| Project | IEEE 802.16 Broadband Wireless Access Working Group < <u>http://ieee802.org/16</u> > |
| Title | A new method for downlink burst profile management in mobile environment |
| Re: | IEEE P802.16e/D5-2004 |
| Abstract | This contribution proposes a new method to improve the DL burst profile change management procedures in mobile environment. |

Figure 80a—Transition to a less or more robust DL burst profile-MSS

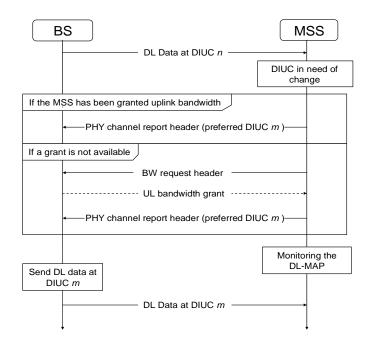
For mobile operation, the DL-MAP_IE should include the CID field (i.e. the CID used is enabled in SC and SCa PHY), the MSS can use PHY channel report header to inform the BS of its *preferred DIUC* (see Figure 20a) whenever, e.g. while decoding DL-MAP, it detects that the CINR goes outside of the allowed operation range. The procedures are shown in Figure 80a, Figure 81b and Figure 81c. The ability of change of DIUC using PHY channel report header is optional for the MSS and mandatory for the BS.

[Insert new figures 80a, 80b and 80c after Figure 80.]
